CAMPAGNE QUALITE #2025-001

Numéro Campagne Qualité	#2025-001
Objet de la Campagne Qualité	Correction montage poulies de renvois Rutgerson Roof
Modèle concerné	44#Open
Numéro de coque concernés	44#001 - 44#055 inclus

NAUTITECH QUALITY CAMPAIGN #2025-001

Quality Campaign number	#2025-001
Subject of the Campaign	Correction of Rutgerson Roof pulley assembly
Affected Model	44#Open
Affected Hulls	44#001 - 44#055 included

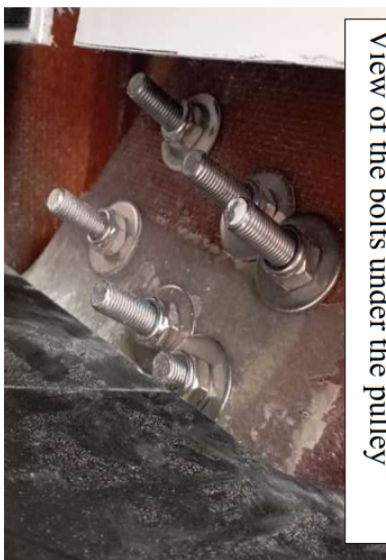
Following various reports of warping of the sheaves of the Rutgerson blocks installed on the roof of the Nautitech 44 Open, we have checked the installation of our fittings.

We found that the 44 Open at Nautitech yard had been incorrectly fitted. This led us to conclude that the fitting had been mounted in a similar way on all the 44 Opens already delivered. We have identified hulls #001 to #055 as potentially affected.

We have validated the installation of supporting plates under the pulleys to correct the assembly.

The size of these Ertacetal plates varies if the Genoa Pre-Fitting option or the Genoa was ordered via Nautitech, as there is an extra single pulley on the port side. We obviously know the boats we have fitted, but some owners may have installed an extra single block after delivery.

1	Unbolt the pulleys from inside the saloon, under the lining.
2	Remove the pulleys and leave their black backing plate in place.
3	Remove the excess silicone on the pulleys and in the roof holes
4	If the genoa option is not selected, place a 3-sheave wedge on the port side. Hold 4 sheaves in all cases to Starboard.
5	Assembly: Position the ertacetal plate between the black counter plate and the pulleys (as in the visual below)
6	Waterproofing: SIK A 291i white
7	Fixing: M12 lock nut + washer inside the square

Position the thicker side of the wedge towards the outside of the boat.
